CO-OP MINING COMPANY

February 12, 1987

RE: Bear Canyon Modification to
Include Mining Hiawatha Seam

Figure 7-F1

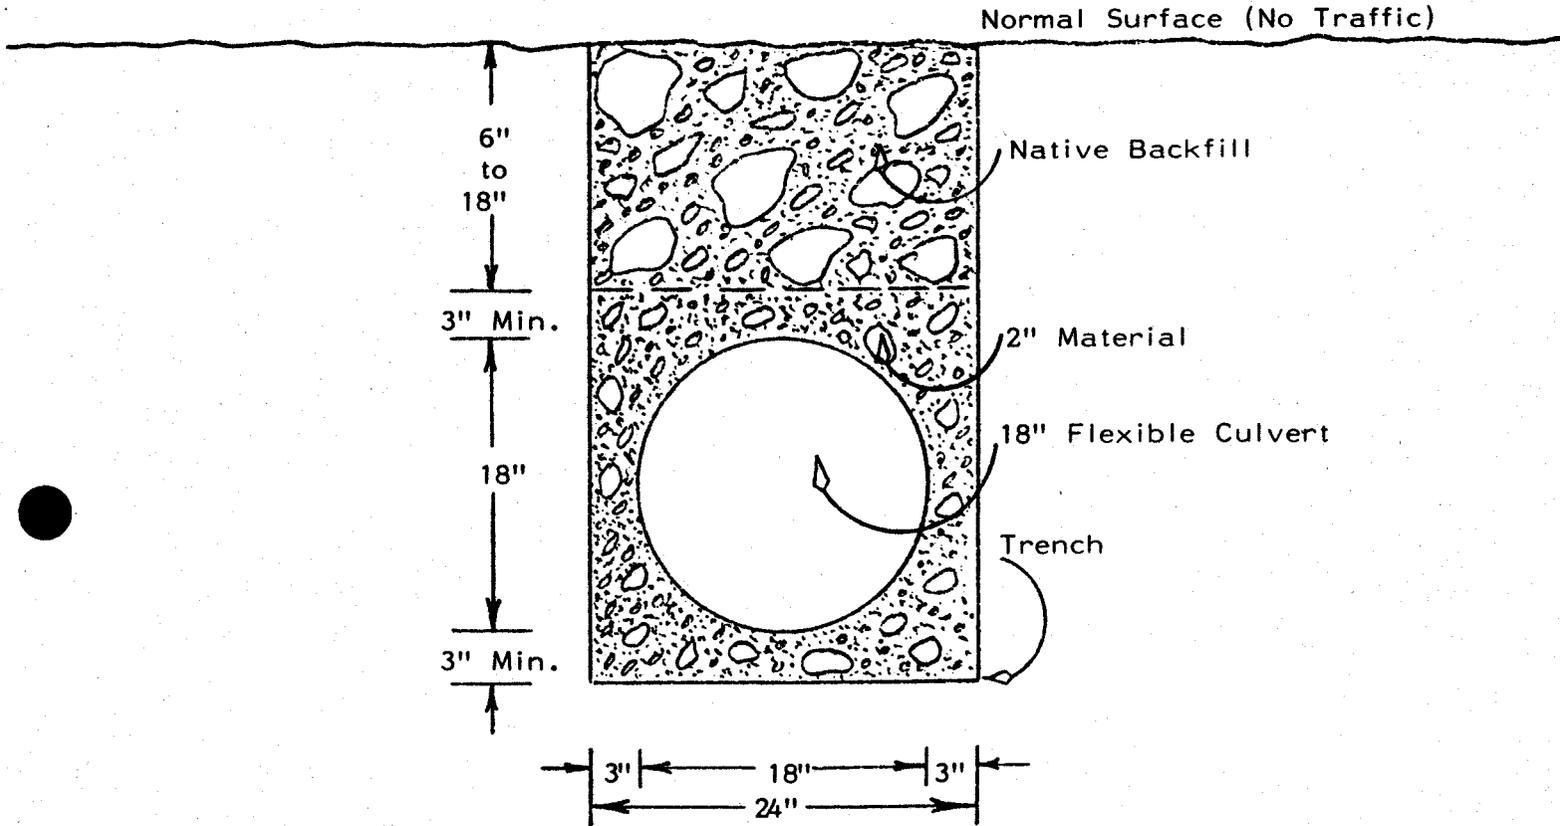
As shown on Plate 2-2, the outslope of the proposed Hiawatha Seam portal pad will encroach upon the ephemeral channel between D-1D and d-2D on Plate 7-8. It is proposed to install a 15" flexible culvert as shown in Figure 7-F1 and 7-F2 to convey the drainage from the upper areas of the channel beneath the pad. The outlet protection for the flexible culvert shown on Plate 2-2 will adhere to the specifications as indicated on pages 83-B3, B4 and page 64A Bear Canyon MRP. The rip-rap and filter blanket specification will be adhered to as specified.
